# Edera at Coconut Point

# Summary of Proposed Amendment to Coconut Point MPD

## Revised since 11-22-16 Planning & Zoning Board hearing:

### Tract 1A Conceptual Site Plan:

## **REQUESTED DEVIATIONS:**

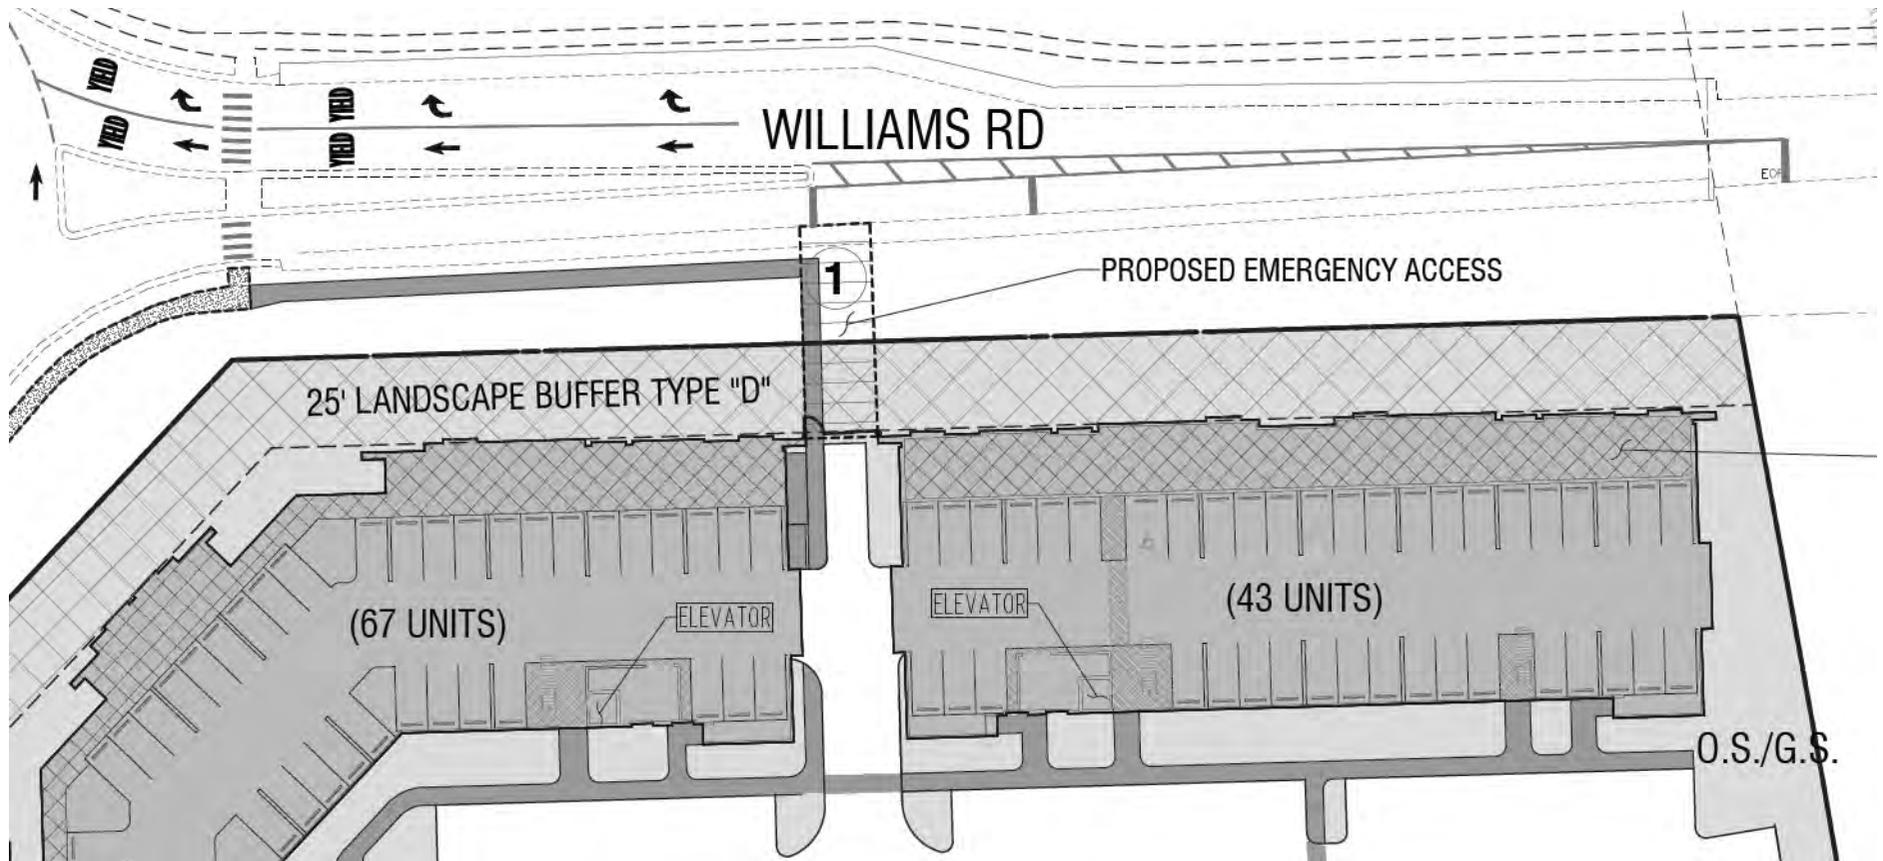
1. Relocation of sidewalk to south side of entry way in order to provide access to the transit stop/pedestrian shelter;

2. Revision to deviations to indicate that three have been withdrawn;

1. Deviation (1) seeks relief from the LDC §10-291(3) requirement, that residential developments of more than five acres must provide more than one means of ingress or egress for the development, to allow for one point of ingress and egress into the development with one emergency access as depicted on Conceptual Site Plan.
2. Deviation (2) seeks relief from the LDC §34-2020(a) requirement to provide a minimum of two (2) parking spaces per multiple-family unit, to allow the parking standard as shown on the Conceptual Site Plan.
3. Deviation (3) has been withdrawn.
4. Deviation (4) has been withdrawn.
5. Deviation (5) has been withdrawn.

## 3. Addition of emergency access onto Williams Road;

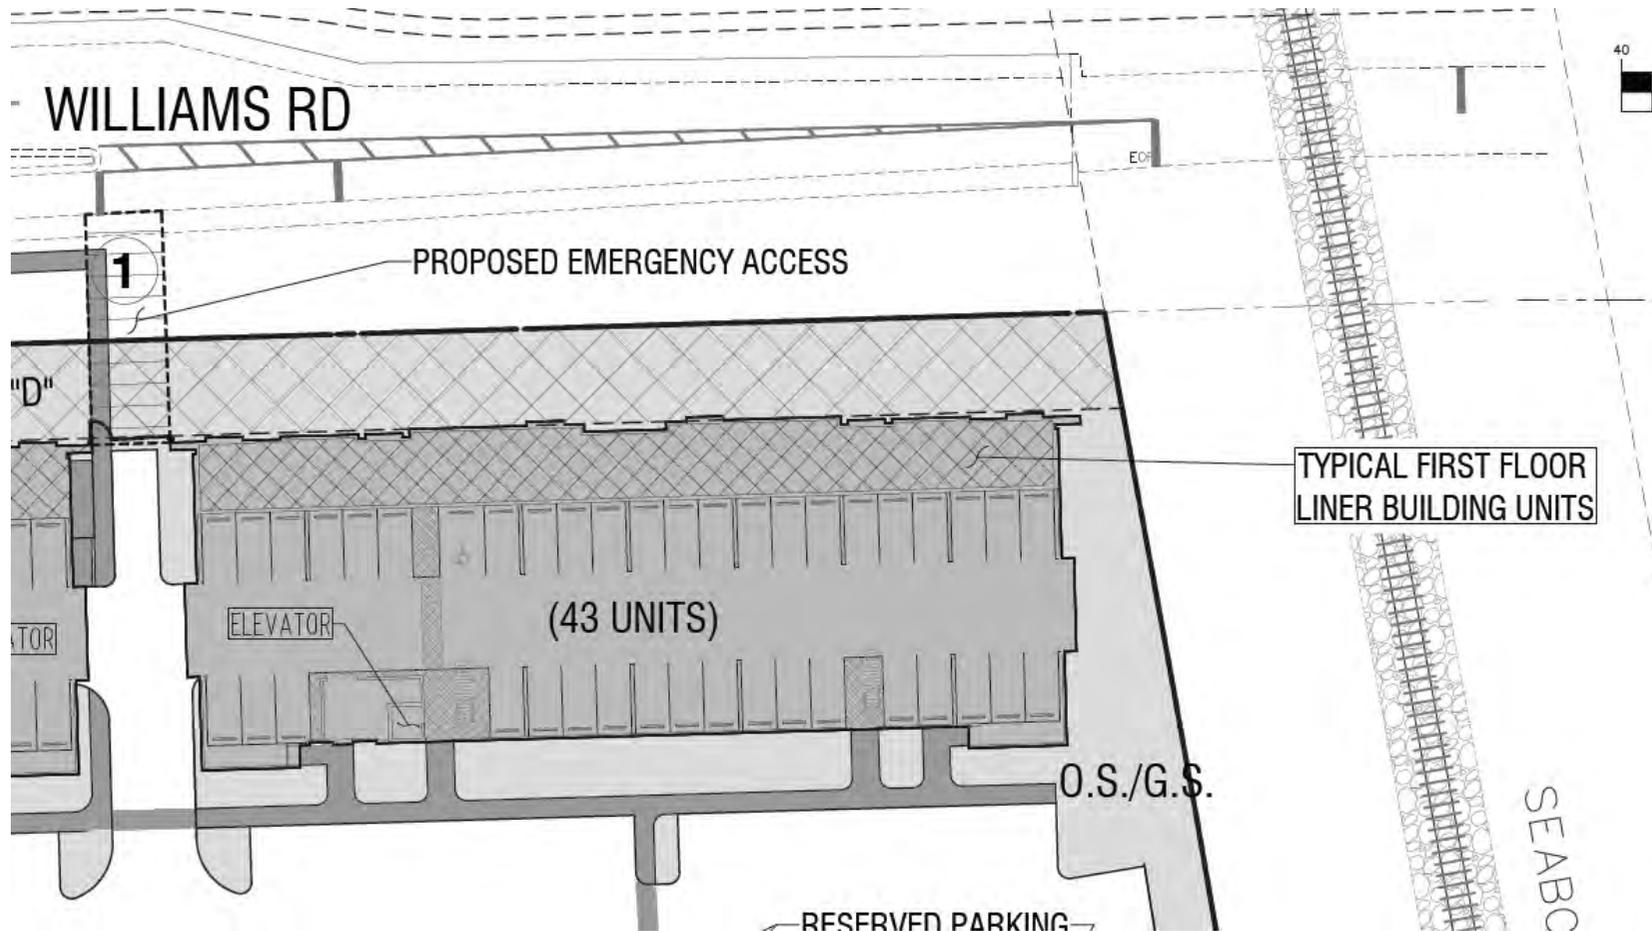
4. Labeled the ground-floor liner buildings/units. The liner units are one-story only;

## **CONCEPTUAL BUILDING ELEVATION**

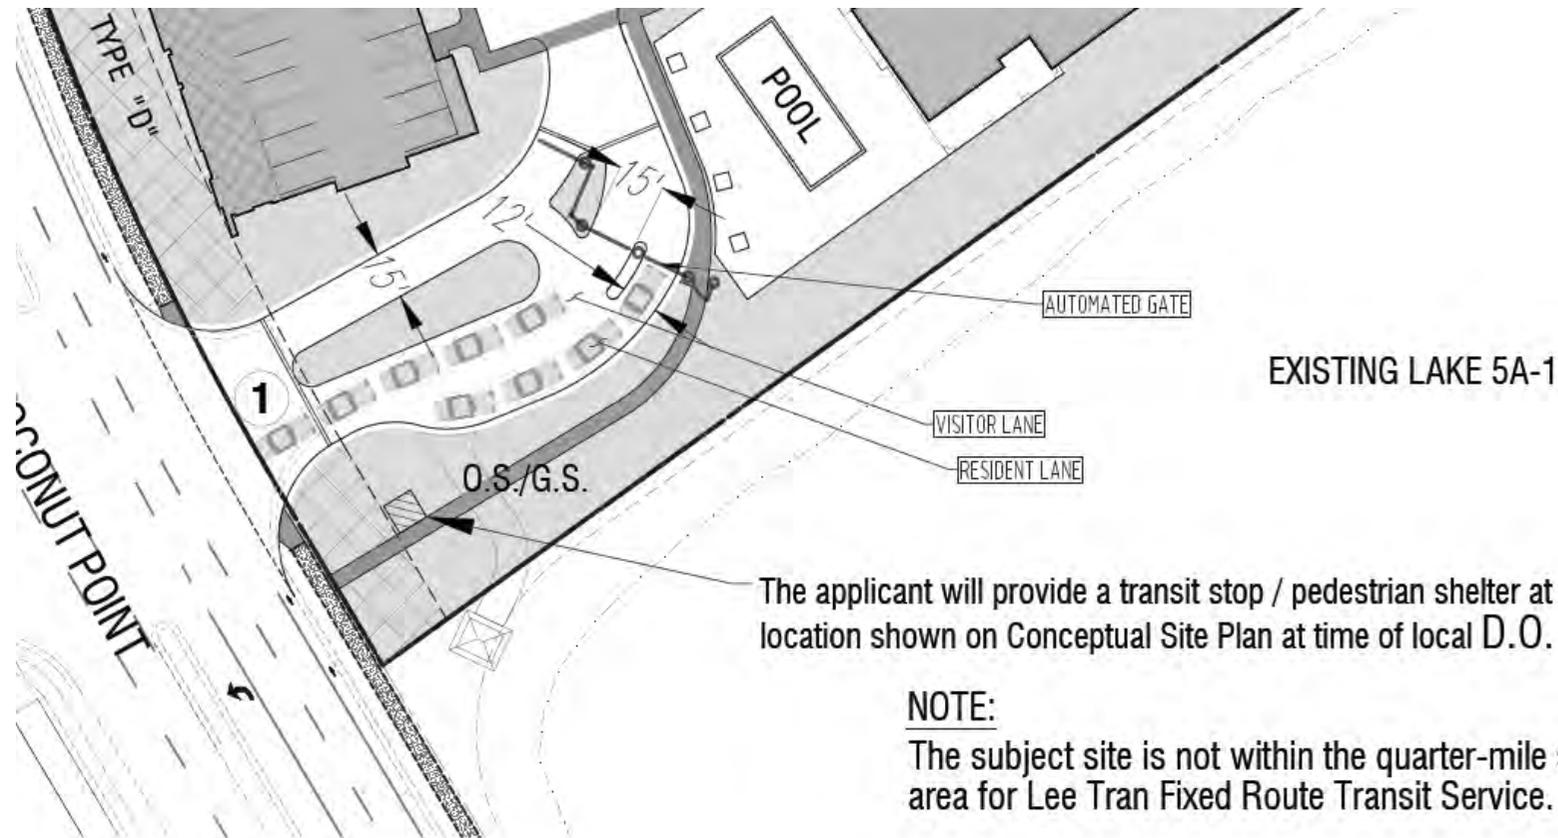
5. Revised the conceptual building elevation to specify that height is being measured consistent with code requirements, specifically per LDC Sec. 34-2171(1);
